Addendum No. 004

**Subject: Rhawnhurst Elementary School- Additions and Renovations
SDP Contracts No. B-070, B-071, B-072 and B-073 of 2019/20**

**Location: Rhawnhurst Elementary School
7809 Castor Avenue
Philadelphia, Pennsylvania 19152**

DRAWING C-500 Utility Plan Addendum #4 (replaces C-500 Utility Plan Addendum #3)

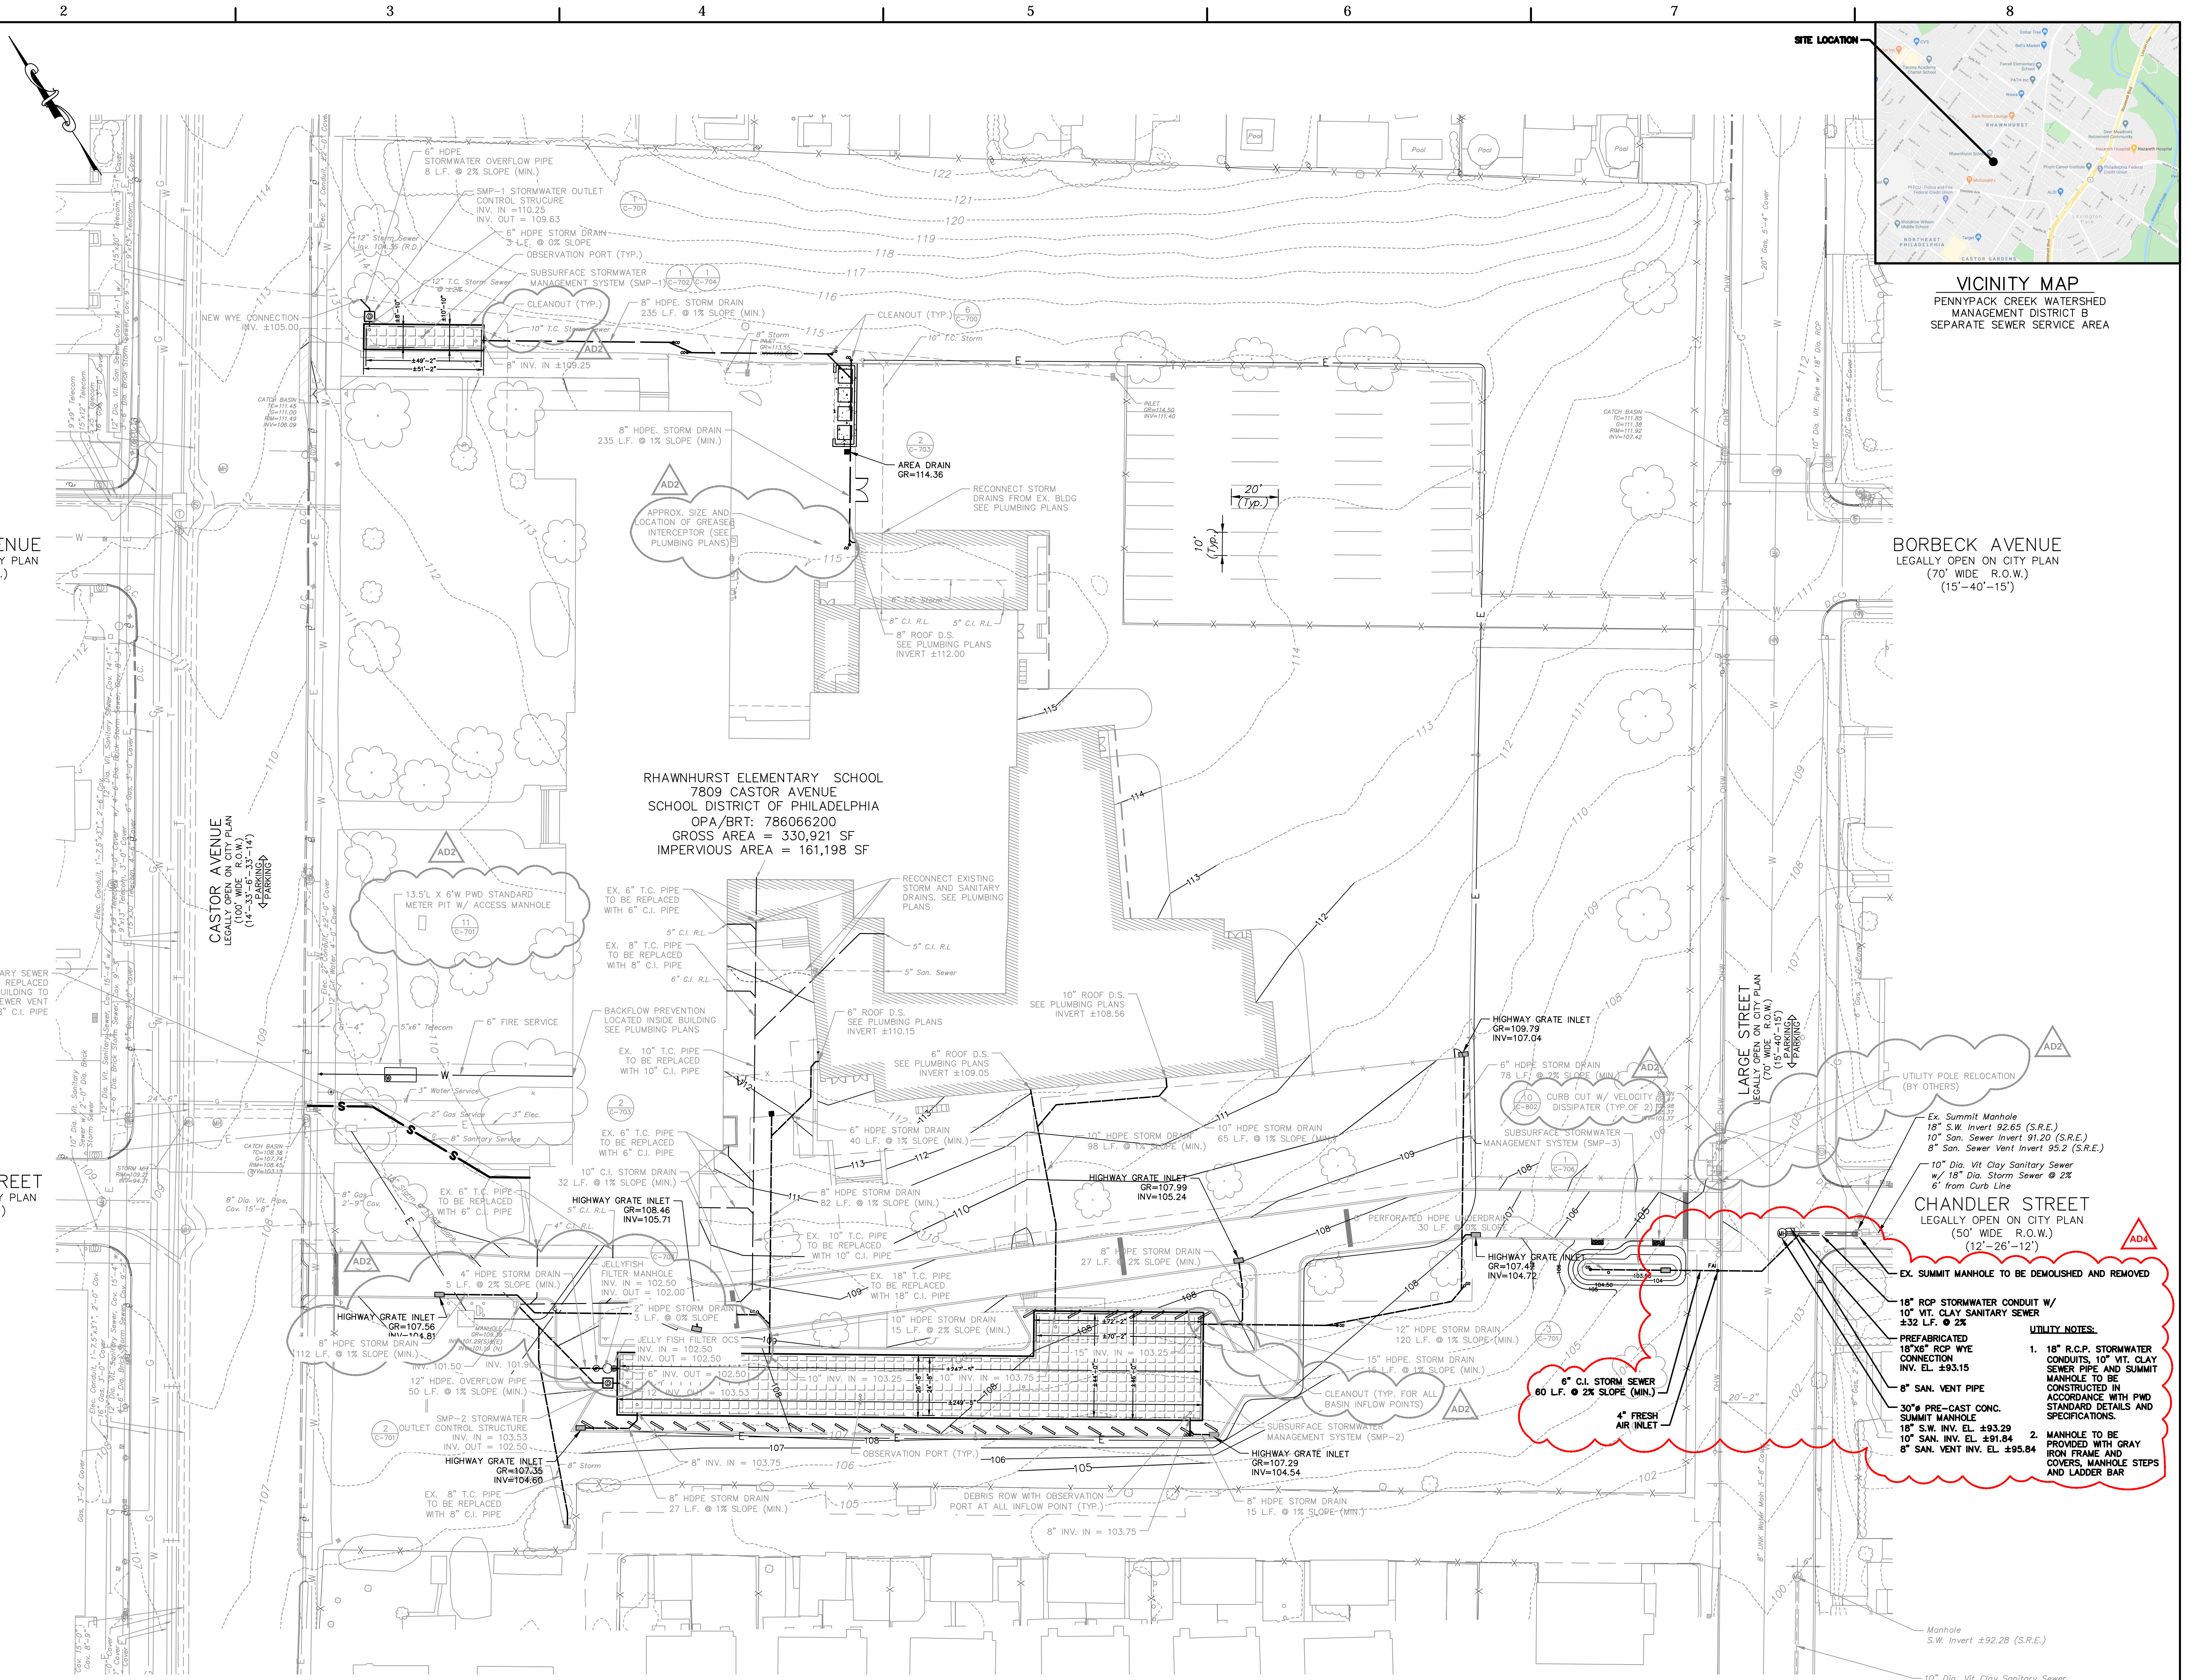
1. **REVISED** SMP-3 6" cast iron storm sewer connection
2. **REMOVAL** of existing summit manhole on Chandler Street.
3. **ADD** Thirty-two (32) L.F. new 18" RCP stormwater conduit W/ 10" vitrified clay sanitary sewer with prefabricated 18"x6" RCP wye connection.
4. **ADD** One (1) 30" pre-cast concrete summit manhole with gray iron frame and cover.
